**KENDALL COUNTY**
**ZONING BOARD OF APPEALS**
**PUBLIC HEARING/MEETING**
110 West Madison Street • Court Room • Yorkville, IL • 60560
(630) 553-4141 Fax (630) 553-4179

# AGENDA

January 27, 2025 – 7:00 p.m.

2. **Petition 24 – 30 – Nicholas S. Bellone on Behalf of Ament Solar 1, LLC (Tenant) and Janet M. Dhuse on Behalf of the Janet Dhuse Declaration of Family Trust Dated March 1, 2013 (Owner) (Pages 15-864)**

C-3.0
GRADING AND EROSION CONTROL PLAN

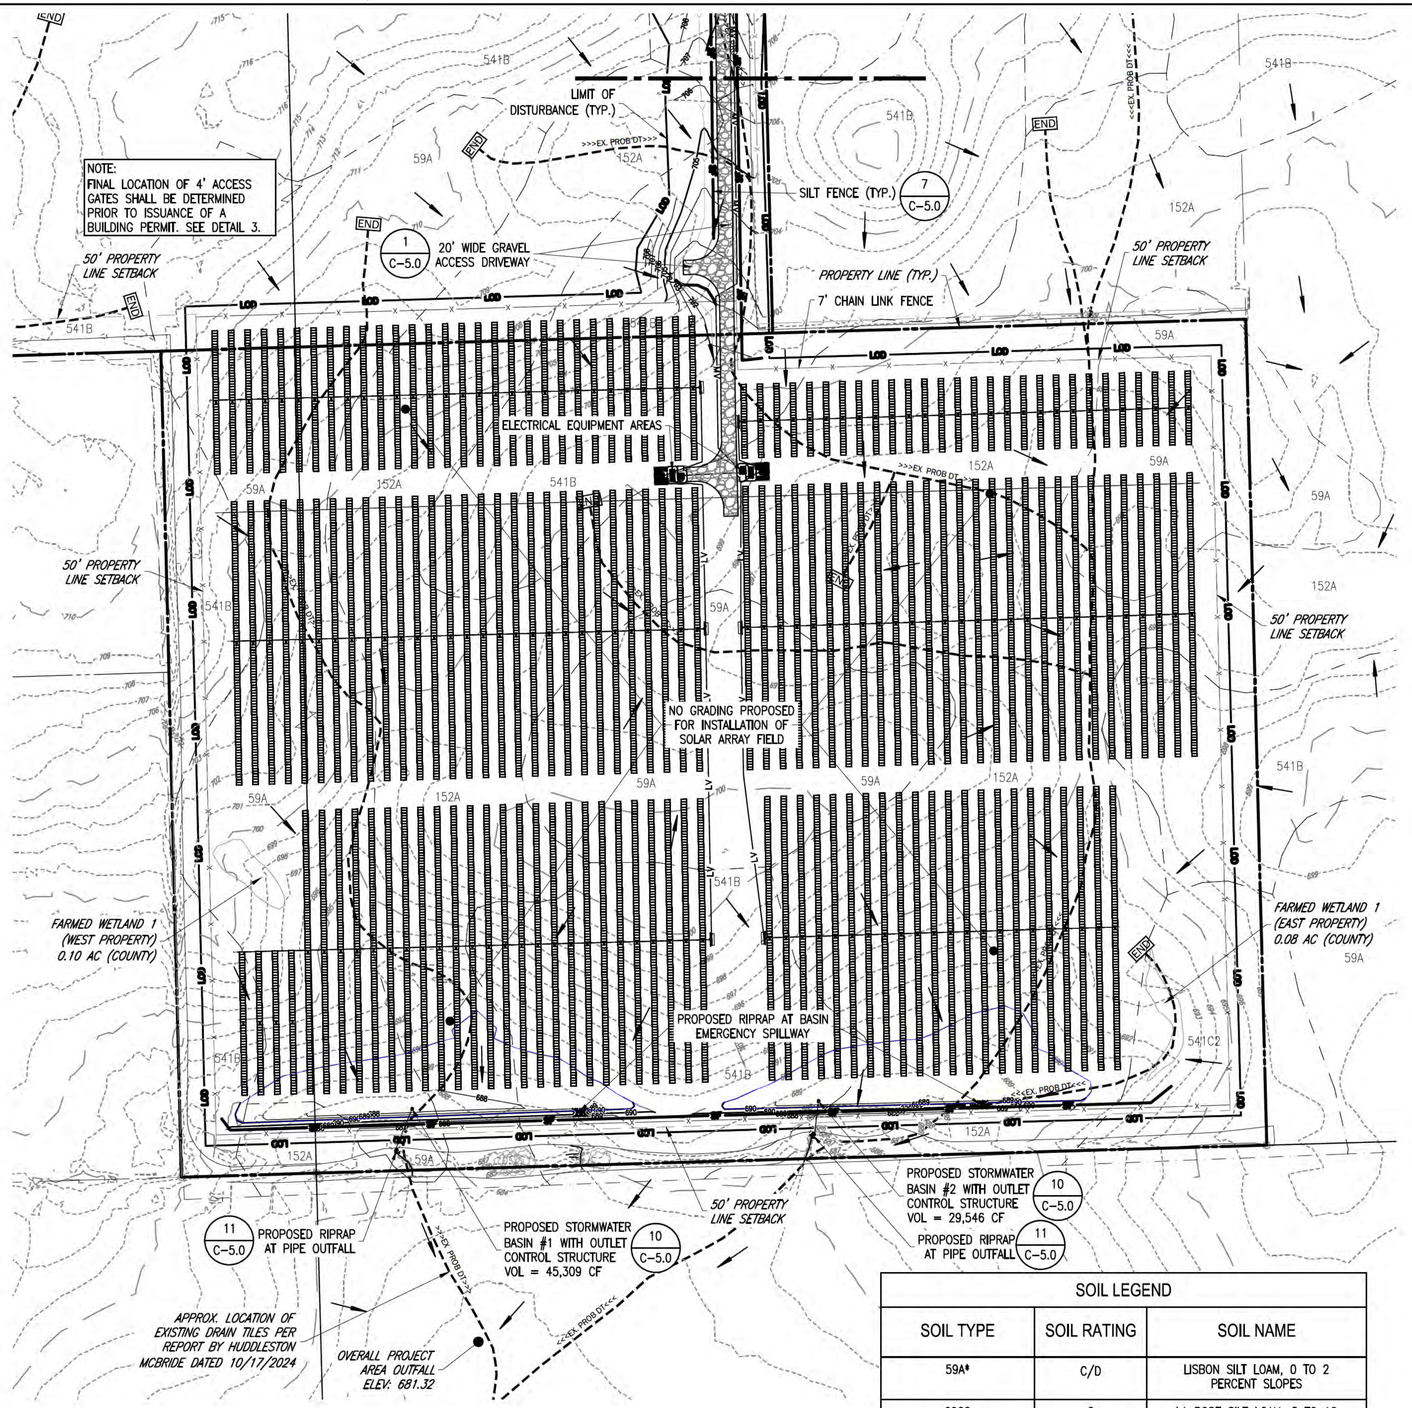
2. Sheet C-3.0: Please include drainage pattern arrows and locations of site outfalls. It is noted that these will be existing drainage patterns to be maintained.
3. The specifications and notes both indicate instances where erosion control blanket is required. Please confirm erosion control blanket is not proposed. If erosion control blanket is to be provided, please note this in the landscape plan (Sheet C-5.0) and provide the associated detail (Sheet C-4.0).
4. Sheet C-3.0: The concrete washout basin appears to be located outside of the silt fence. Please relocate or confirm in the call out that the concrete washout basin shall be located within the silt fence.

2. Sheet C-3.0: Please include drainage pattern arrows and locations of site outfalls. It is noted that these will be existing drainage patterns to be maintained.
    - **NLE Response: These have been added to Sheet C-3.0.**

4. Sheet C-3.0: The concrete washout basin appears to be located outside of the silt fence. Please relocate or confirm in the call out that the concrete washout basin shall be located within the silt fence.
    - **NLE Response: The limits of the silt fence has be relocated around the concrete washout basin.**
